## PROJECT MEMORANDUM

Subject: Report - Geotechnical Study, Lot 15 Ski Lake Estates No.3, 6640 East 1100 South, Huntsville, Utah, prepared by Earthtec Engineering Inc. (project no. 145150G), dated June 23, 2014, prepared for Mr. Martin Nabs, 50 River

SA Project No: 15-142

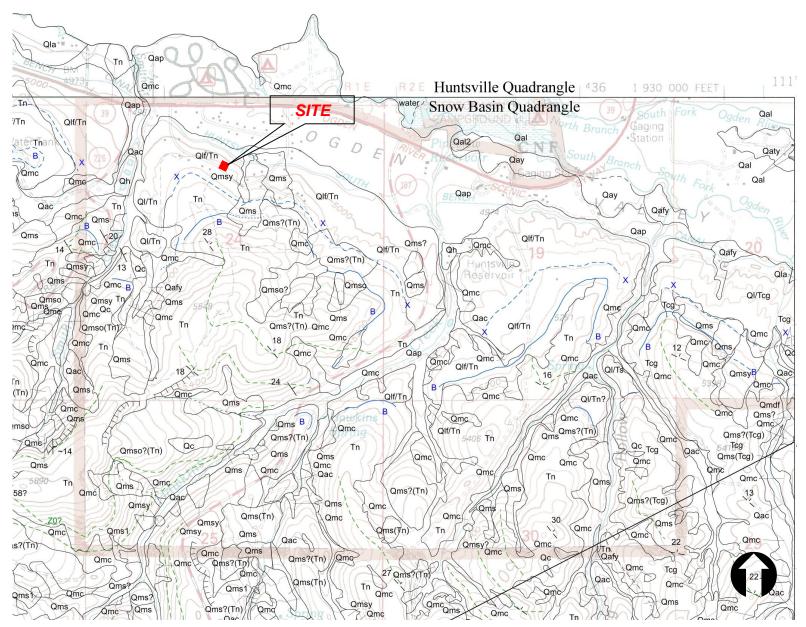
As requested I reviewed the above referenced report to evaluate whether or not the site is located in a geologically sensitive area. It is my opinion the site is located in a geologically sensitive area. As shown on the attached geologic map:

- 1. The site is underlain by geologic unit Tn, Norwood Formation, an extremely landslide-prone geologic unit. Personally, I believe any site underlain by Tn should have a qualified engineering geologist, at a minimum, review, if not log, subsurface explorations.
- 2. There are several landslides in the immediate vicinity of the site (geologic unit Qms), all within unit Tn. Please note that I only included the geologic description of the units in the immediate vicinity of the site on the attached geologic map.

Based on the documents reviewed and my experience in the area, specifically with the Norwood Formation, I recommend the site be treated as a geologically sensitive (e.g., hazardous) site and also be evaluated by a qualified engineering geologist. Should you have any questions, please feel free to contact me.
